South Texas Project Electric Generating Station P.O. Box 289 Wadsworth, Texas 77483

December 4, 2008
U7-C-STP-NRC-080067

South Texas Project
Units 3 and 4
Docket Nos. 52-012 and 52-013

Commitment Related to Tsunami Effects and Response to Request for Additional Information

Figure 13. Maximum coastal run-up for the PV case was 1 m.

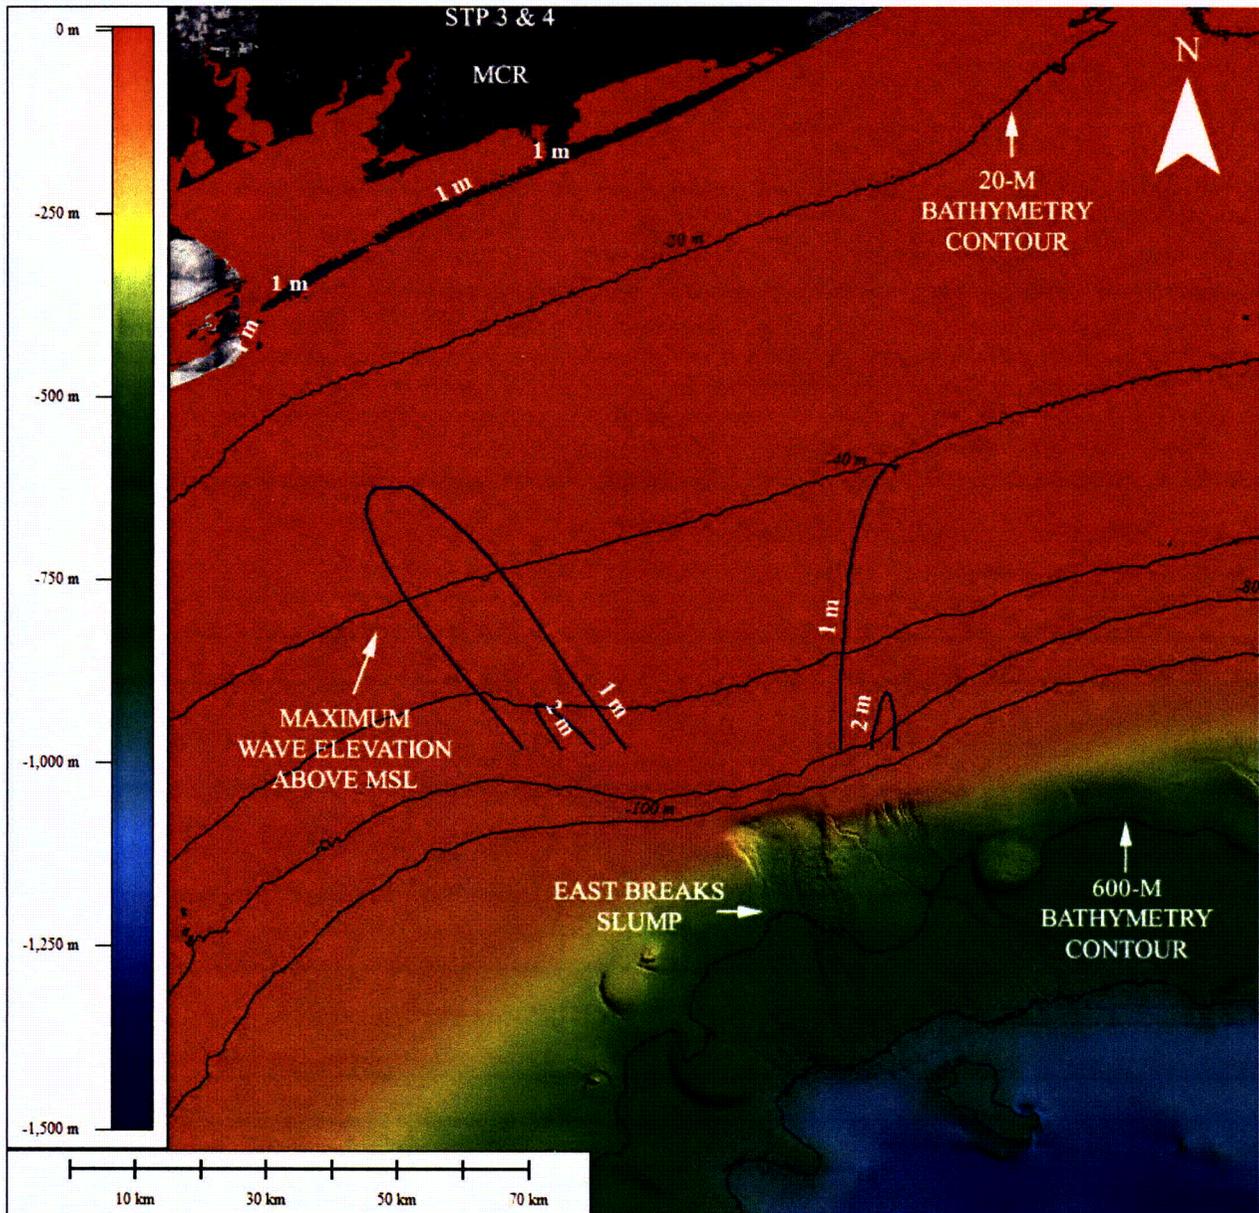
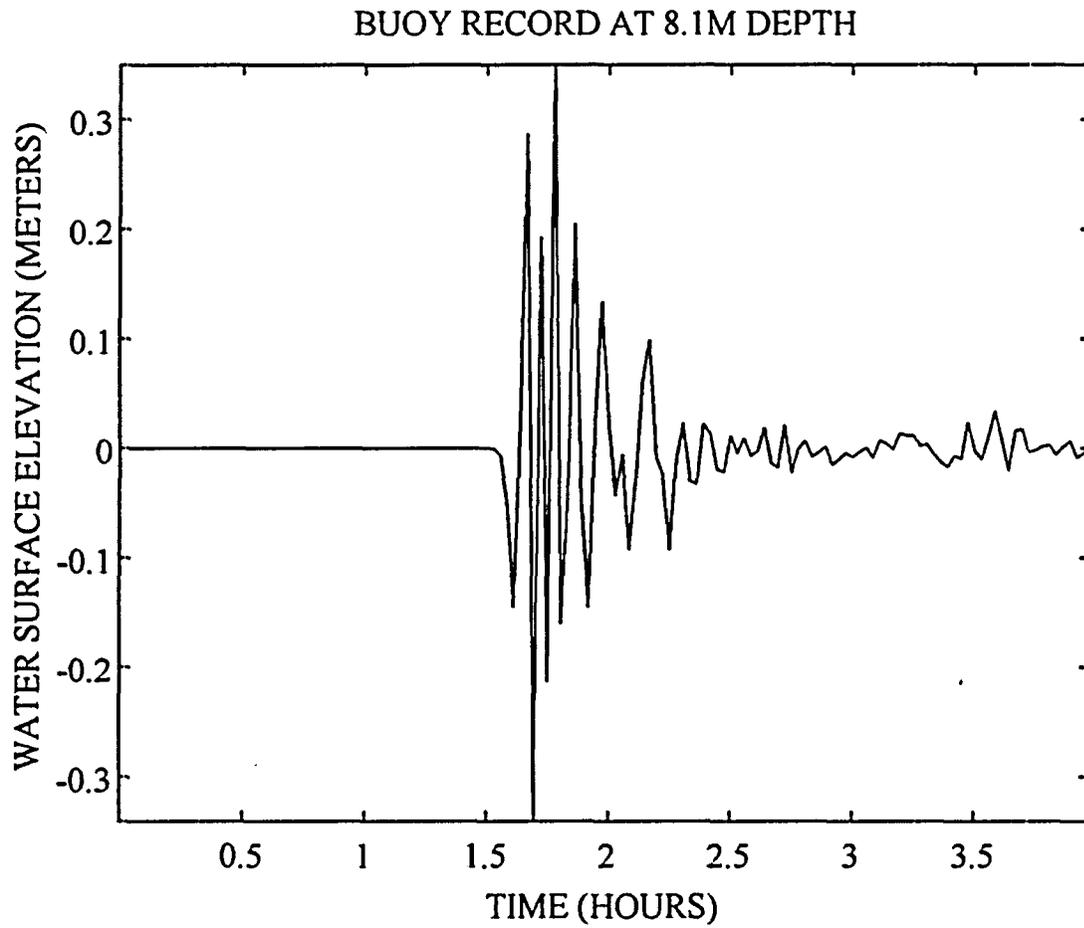
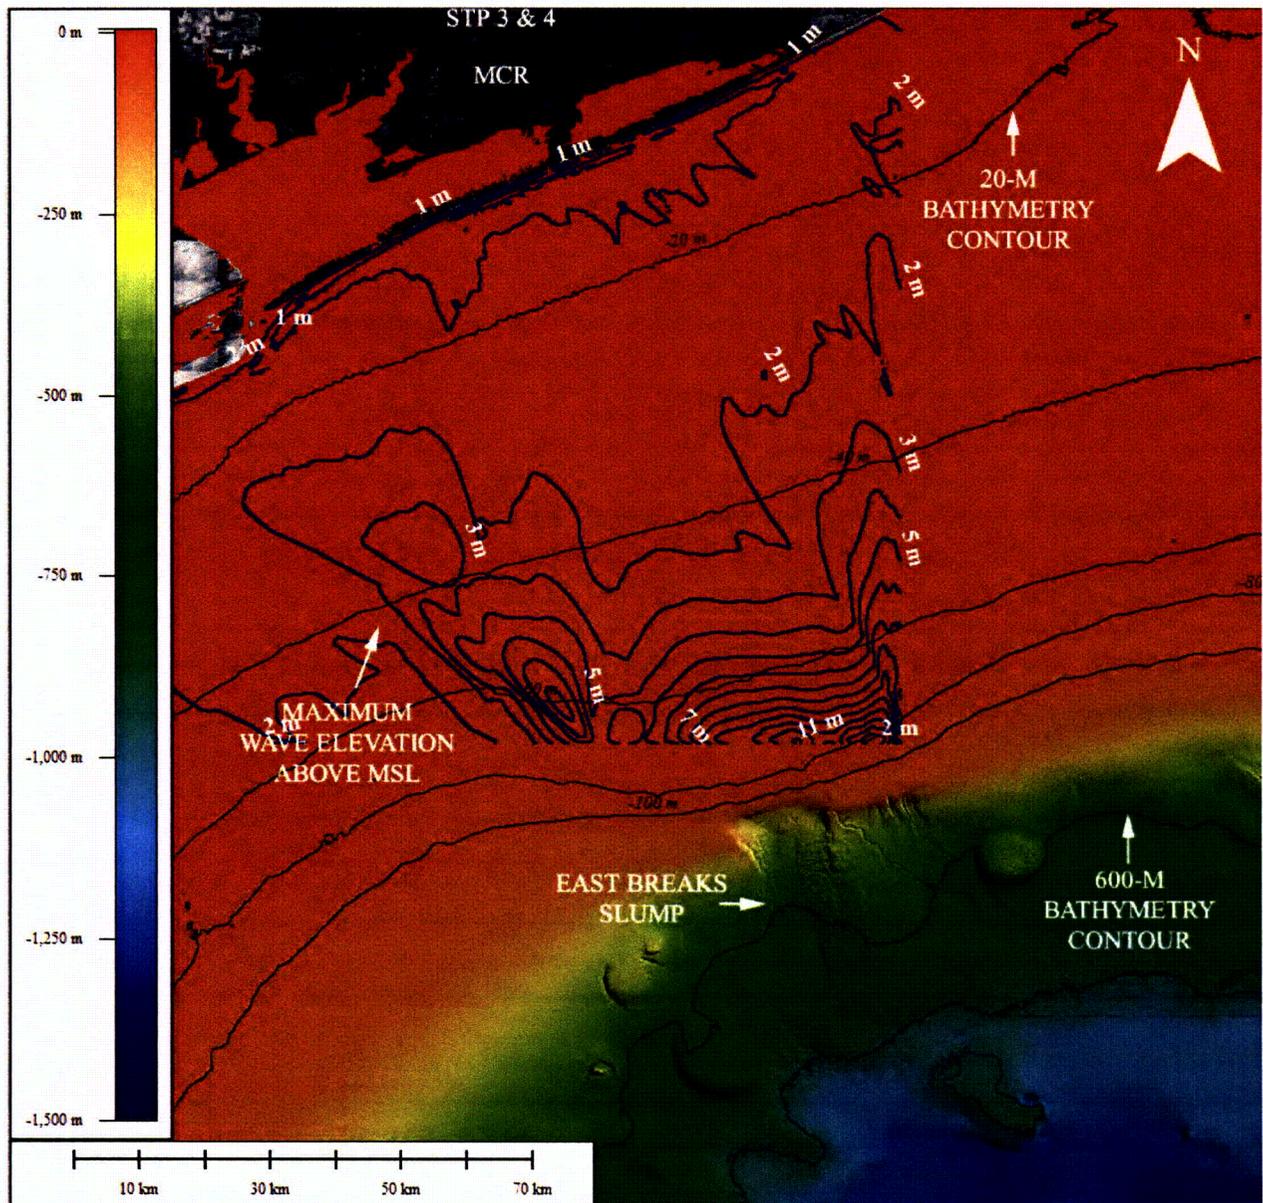
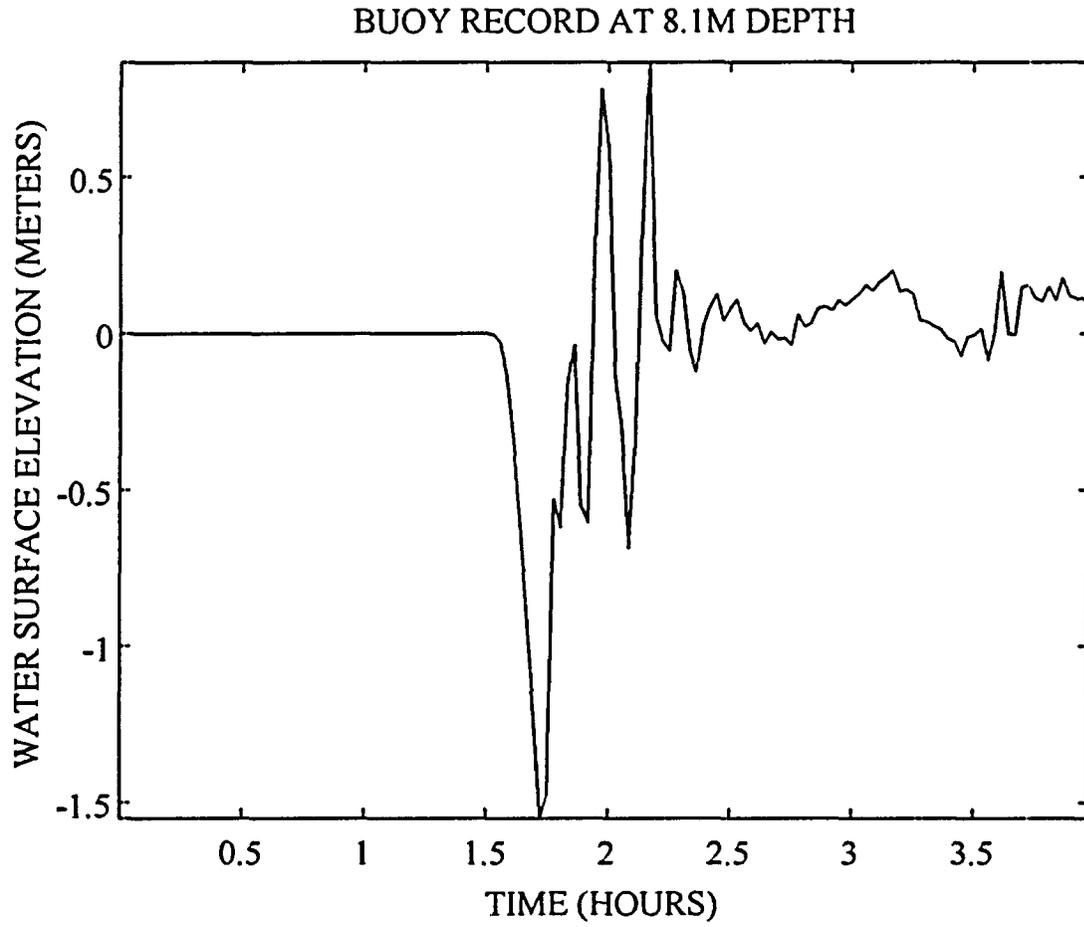
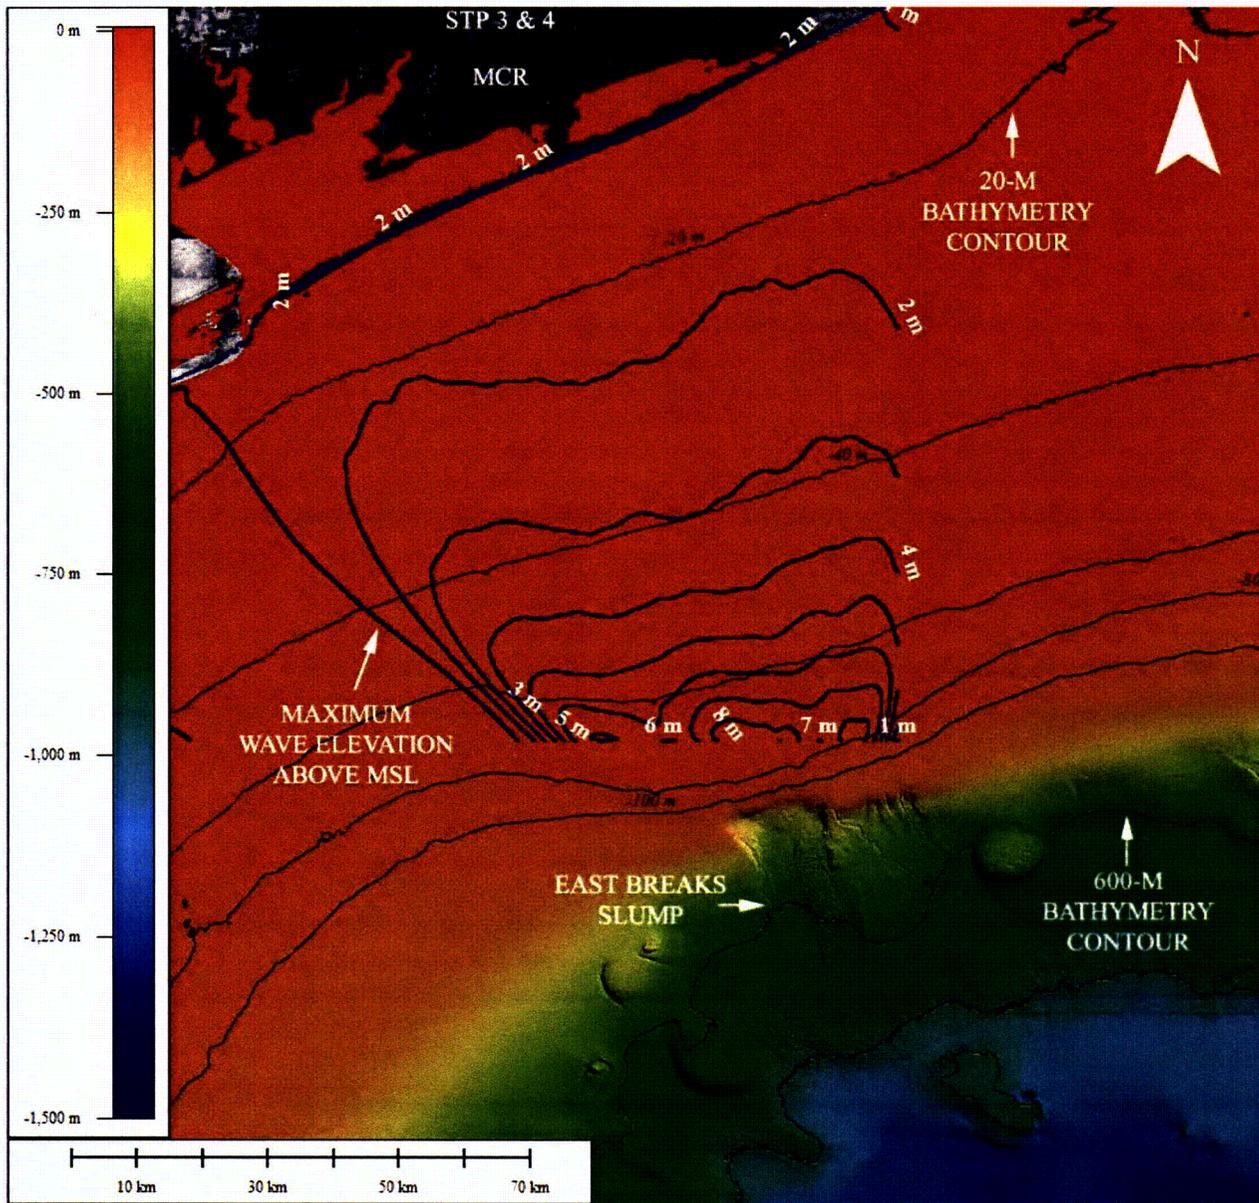
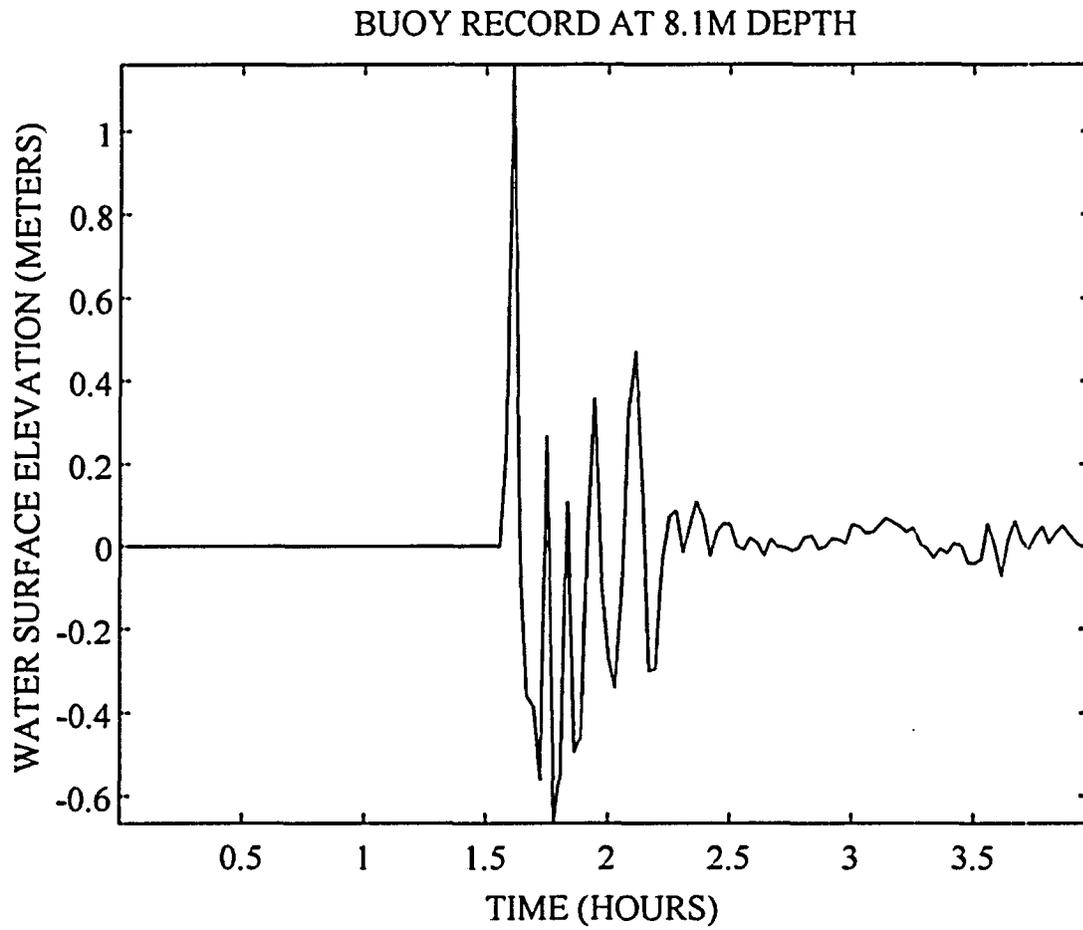
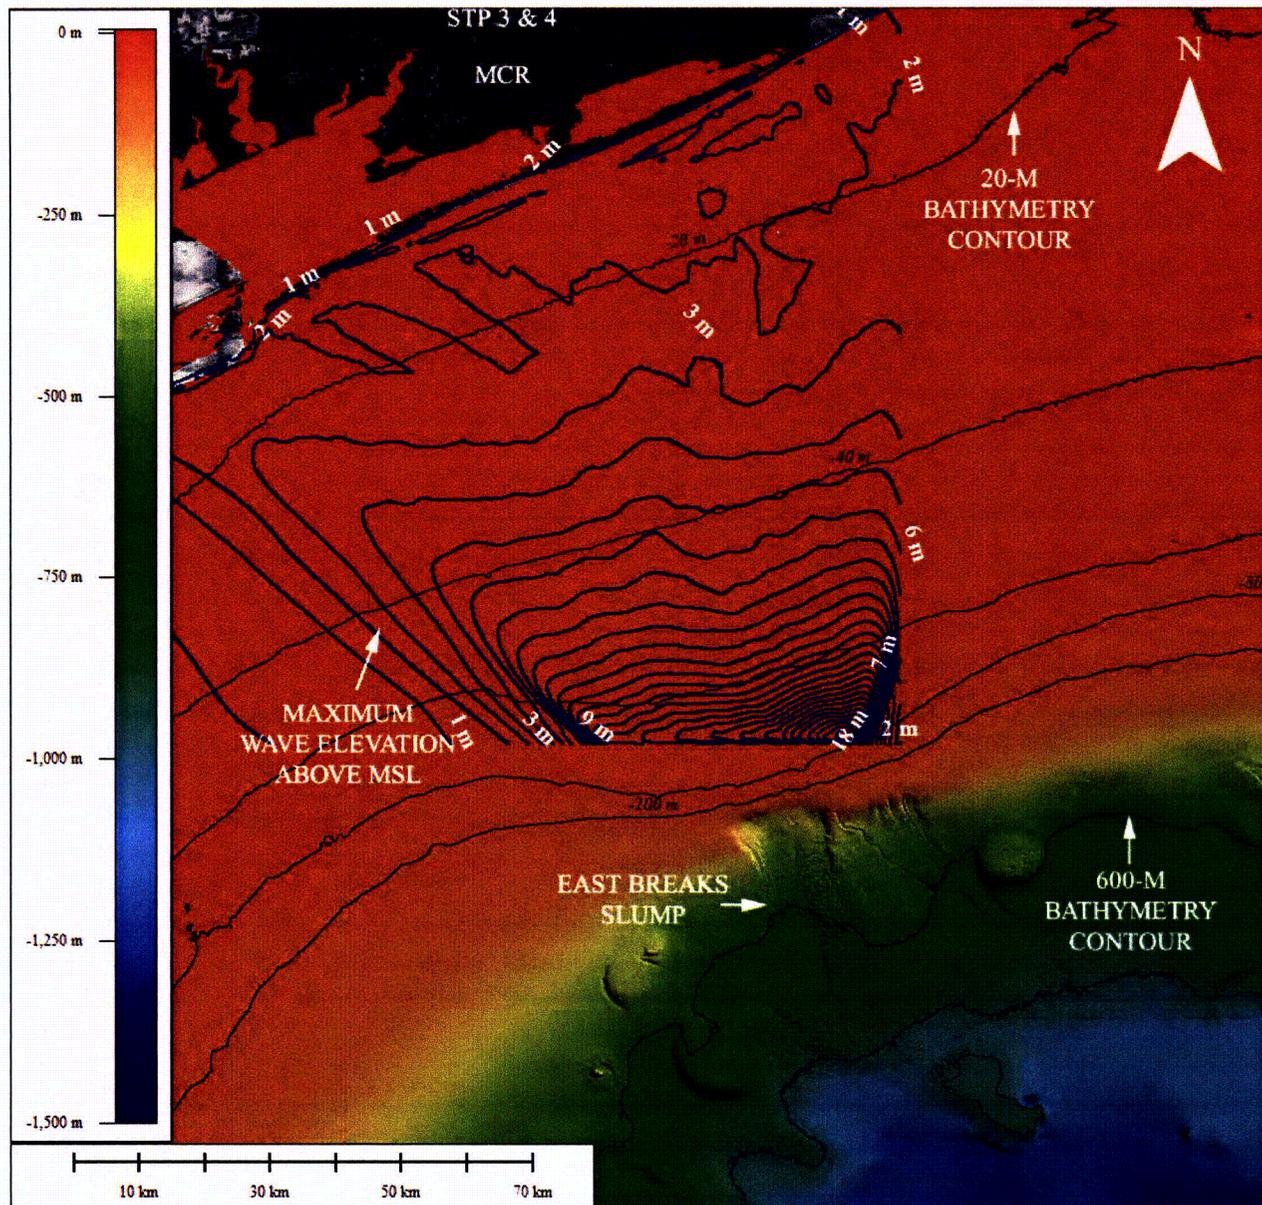
[Item 1] Provide an assessment (e.g., tsunami modeling analysis) of the East Breaks landslide to clarify whether the 7.6 m offshore wave height indicated by Trabant et. al. (2001) can be discounted.

MOST output includes run-up estimates (i.e., maximum inland elevation inundated by the tsunami above MSL). Maximum run-up ranges from 1 to 2 m (3.3-6.6 ft) (MSL) for the South Texas coast near STP 3 & 4 (Table 1). Plots of maximum wave amplitude relative to South Texas coast bathymetry are shown for PV, PV(x20), PNG, and the hypothetical “Monster” cases in Figure 13, Figure 15, Figure 17, and Figure 19, respectively. Time series and period of water surface elevation above MSL for a buoy location near the South Texas coast for the PV, PV(x20), PNG, and hypothetical “Monster” are shown in Figure 14, Figure 16, Figure 18, and Figure 20, respectively.
